Evaluation of Physical Barriers – West Corona Station

Address: 155 Auto Center Dr, Corona, CA 92880

Evaluation Date: 07-27-2021

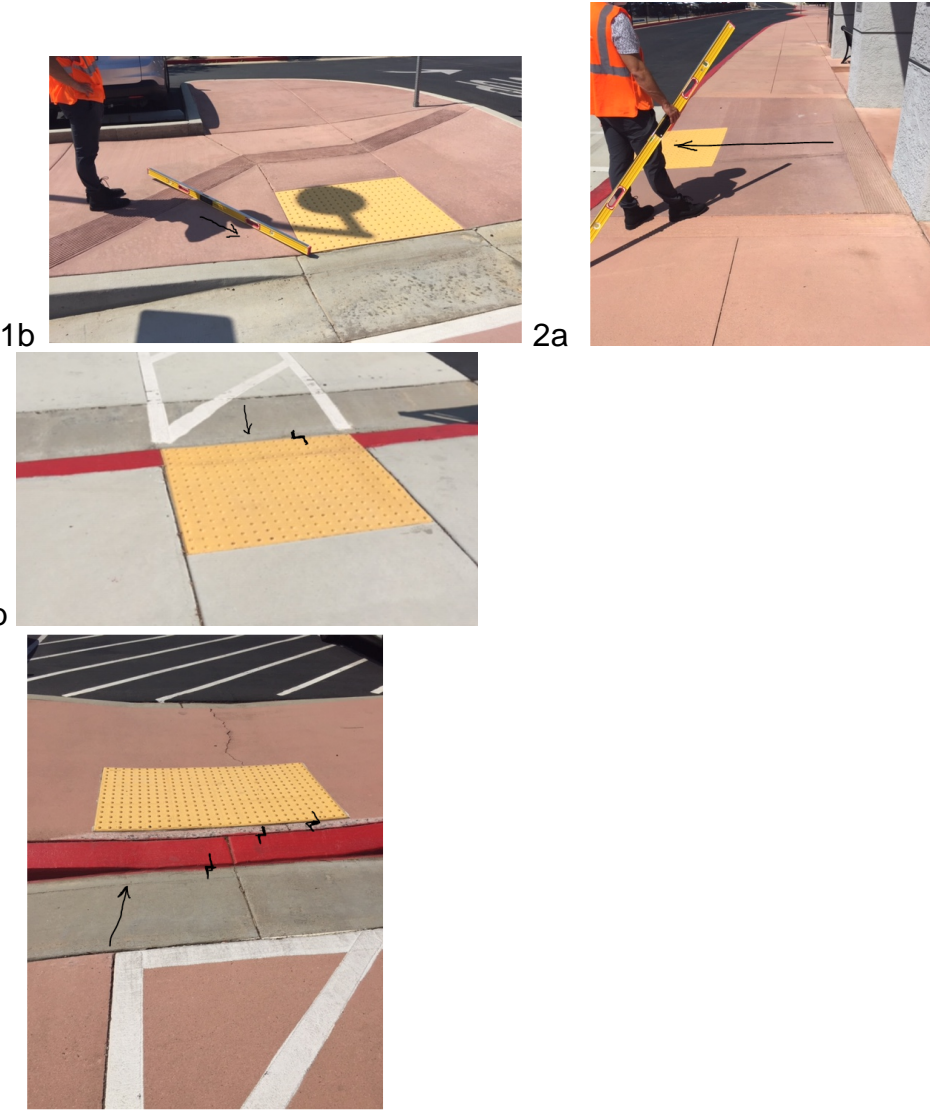
Issues/Barriers Identified	Recommendations	Comments
<p>1. Curb Ramps</p> <p>1a, OK 1b- Flared side exceeds 1:10 slope (11.6%) 2a- Sloped ramp takes up the entire sidewalk in front of the main entrance. Landing is under the station canopy 2b- Gutter slope exceeds 1:20 (9.1%). Flared side exceeds 1:10 slope (12.2%). uneven level changes and trip hazard. 3a - OK 3b- Gutter slope exceeds 1:20, uneven level changes and trip hazards. 4a- Trip hazard at DWS 4b –Ok 4c – Ok 5a, 5b- (Not under RCTC's authority), 6A -OK 7a, 7b- (Not under RCTC's authority)</p> <div data-bbox="149 671 1034 1729">  <p>1b</p> <p>2a</p> <p>2b</p> <p>3b</p> </div>	<p>1b, 2b Repair flared sides of curb ramps to comply with 406.3</p> <p>2a Provide signage for the accessible route along the sidewalk leading to level walking route under the canopy.</p> <p>2b, 3b Remove and replace curb ramp and gutter with compliant curb ramps.</p> <p>4a Examine all Detectable Warning Surfaces (DWS) and repair/replace DWS to eliminate trip hazards. Provide beveled transitions as required</p>	<p>Curb ramps are labeled on the aerial view on page 1</p> <div data-bbox="1765 211 2554 383">  <p>adjoining surface maximum slope</p> <p>20</p> <p>1</p> <p>curb ramp slope</p> </div> <p>Figure 406.2 Counter Slope of Surfaces Adjacent to Curb Ramps</p> <p>406.3 Sides of Curb Ramps. Where provided, curb ramp flares shall not be steeper than 1:10.</p> <div data-bbox="1609 600 2461 866">  <p>flared sides 1:10 max slope</p> <p>slope</p> <p>slope</p> </div> <p>Figure 406.3 Sides of Curb Ramps</p> <p>This evaluation does not include curb ramps outside the RCTC boundary. RCTC is not responsible for maintaining the accessible routes outside of RCTC boundary.</p> <p>When repairs begin, use proper and precise instruments (4-foot smart level and 2-foot smart level) to fit within the curb ramp width and the adjacent gutter to measure ramp slopes, cross slopes, and counter slopes at all curb ramps (all stations). The long slope of ramp shall not exceed 1:12 (8.33%). Slope of flared sides shall not exceed 1:10 (10%), the gutter slope shall not exceed 1:20 (5%). Cross slope of the ramp and landing shall not exceed 1:50 (2%)</p> <p>Use smart level instruments, calibrated in accordance with manufacturer's instructions before taking measurements.</p> <div data-bbox="1560 1395 2088 1576">  <p>1/4</p> <p>6.4</p> <p>1/4</p> <p>6.4</p> <p>2</p> <p>1</p> <p>1/2</p> <p>13</p> </div> <p>Figure 303.3 Beveled Change in Level</p>

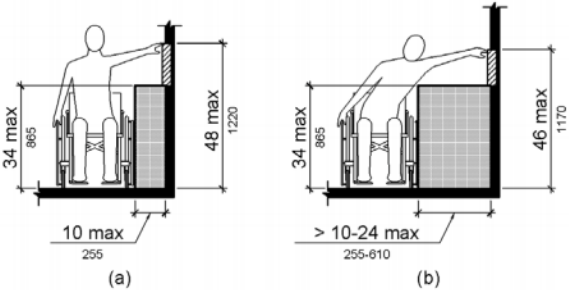
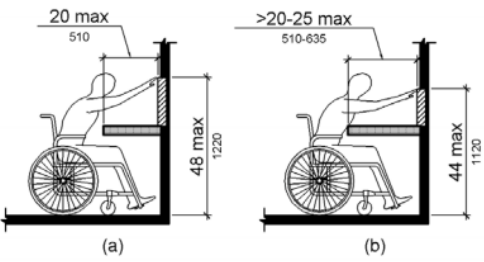
Issues/Barriers Identified	Recommendations	Comments
3. Accessible Routes		
a) Walking surface		
<p>i. From curb ramp 5a, a sidewalk entering the facility is provided. The slope of the sidewalk is measured as 9.6% which matches the grade of the road but exceeds the maximum allowed slope for accessible ramps.</p> <p>ii. A vehicular ramp into the gated areas is perpendicular to the sidewalk described above . This causes a steep drop and excessive cross slope for the already steeply sloping sidewalk.</p> <p>iii. General: There are uneven joints and cracks observed in the concrete on the platforms and along accessible route. Sealant/filler in some deep joints is missing. This causes trip hazards and creates openings deeper than ¼” and wider than ½ inch that do not comply with 302.3 and 303.3. (Figure on previous page)</p> <p>iv. Manhole covers create trip hazards and have gaps/openings wider than ½ inch.</p> <p>v. Signage designating the accessible route is missing at main entry.</p>	<p>i) The grade of the sidewalk along the road complies with the requirements of City of Corona, DIB-82-06 and PROWAG if the ramp is considered a public street. If the ramp is considered to be an entry to private property, then these requirements are not applicable, and this ramp is considered out of compliance.</p> <p>RCTC being a public agency, it can be assumed that the commuter rail stations owned by RCTC would be public property. It is recommended prior to initiating any repairs on the ramp, that this issue be reviewed by an ADA legal expert to determine final resolution.</p> <p>ii) Same as above. An alternate accessible route is required.</p> <p>iii) and iv) Repair all level changes. Close gaps and openings wider than ½” and deeper than ¼”, and remove trip hazards in the accessible route.</p> <p>v) Provide signage designating the accessible route.</p>	<div>  <p>Figure 302.3 Elongated Openings in Floor or Ground Surfaces</p> </div> <div>  <p>Figure 303.3 Beveled Change in Level</p> </div> <div>  <p>Figure 303.2 Vertical Change in Level</p> </div> <p>402.2 Components. Accessible routes shall consist of one or more of the following components: walking surfaces with a running slope not steeper than 1:20, doorways, ramps, curb ramps excluding the flared sides, elevators, and platform lifts. All components of an accessible route shall comply with the applicable requirements of Chapter 4.</p> <p>405.2 Slope. Ramp runs shall have a running slope not steeper than 1:12.</p> <p>405.8 Handrails. Ramp runs with a rise greater than 6 inches (150 mm) shall have handrails complying with 505.</p>

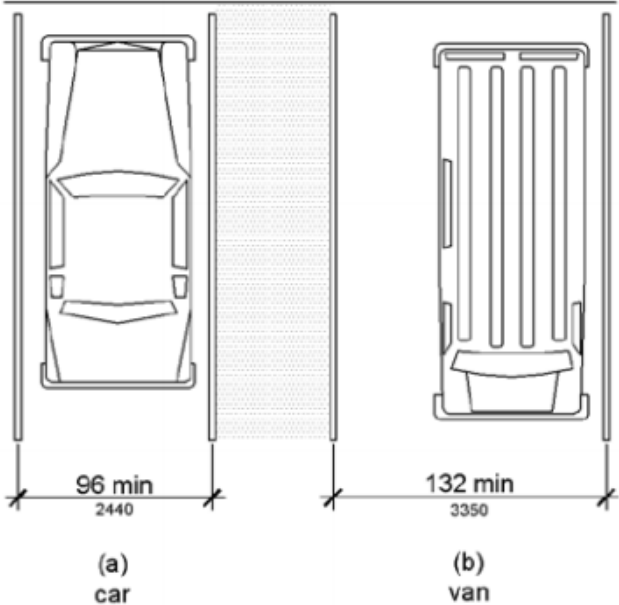
Issues/Barriers Identified	Recommendations	Comments
<p>iii. Downspouts will discharge water onto the accessible route.</p>	<p>Ensure that the rainwater will drain away and will not pond. Eliminate any low spots or uneven pavement. To ensure compliance with 405.10, Wet Conditions, Landings subject to wet conditions shall be designed to prevent the accumulation of water, ensure that the area is in compliance with 403.3 Slope.</p>	<p>405.10 Wet Conditions. Landings subject to wet conditions shall be designed to prevent the accumulation of water.</p>
<p>iv. A trip hazard is created due to a diamond plate cover behind the west mini high platform on track 2</p> 	<p>Remove and replace with a recessed cover</p>	
<p>v. Cross slope on Track 1 platform near the west mini high platform exceeds 2%</p> 	<p>Cross slope needs to be repaired to comply with 403.3 to be no more than 2%. Examine cross slopes throughout the accessible route and repair where needed.</p>
